REVIEW OF THE
PUBLIC SERVICE COMPANY OF COLORADO
PROPOSED
INSERVICE INSPECTION PROGRAM

Submitted to:
LOS ALAMOS NATIONAL LABORATORY

by:
ASTA, Inc.

22 December 1981

FIGURE 1
CIRCULATOR PENETRATION & INLET GAS PLENUM,
SCHEMATIC SHOWING PRINCIPAL
COMPONENTS & AREAS OF INSPECTION

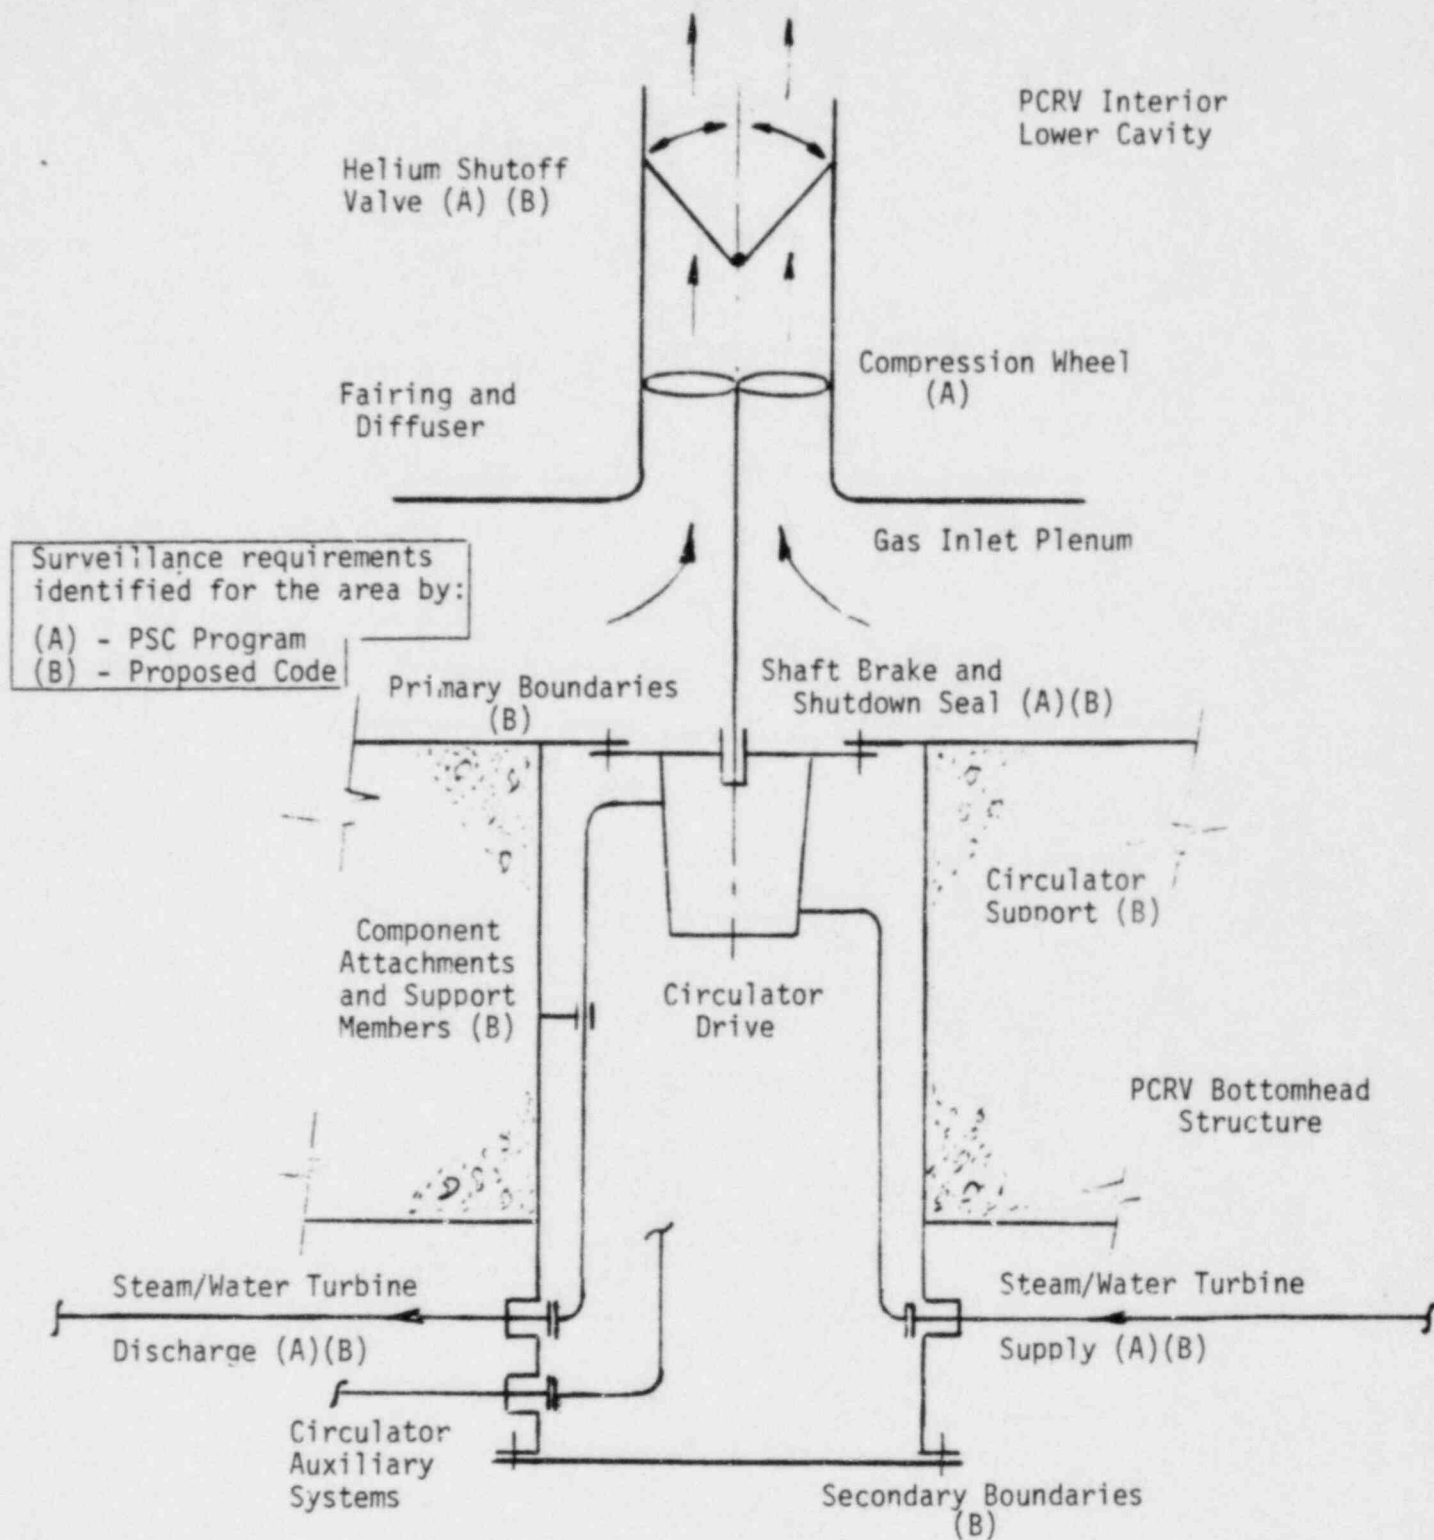
Figure 1 depicts the principal areas of inspection for components of primary loop circulation pertinent to the discussion: the penetration, helium circulator, helium shut-off valve and coolant-loop ducting. The schematic is representative of the FSV concept. It identifies and categorizes areas of inspection interest relative to the proposed requirements of the Code and to those of the PSC program. As a further aid for reviewing the comparative differences in the proposed requirements, attention is directed to Table 2-1 on this SR.

FSV operating experience to date (specifically circulator change-outs and subsequent materials investigative testing and analyses of forms and causes of degradation to drive components) has provided the bases for a meaningful program of surveillance for circulator components. Pressure-retaining boundary examinations should also be an important facet of the planned surveillance program. The position that the double closure concept exempts primary and secondary boundaries from volumetric and surface examinations of welds and bolting neglects the safe shutdown cooling function of this component. For further discussion of this point see Appendix A, item A-1. The occasions for circulator change out provide the opportunity for extensive inspection of penetration interspace boundaries and structures. It is recommended that these inspections include the following:
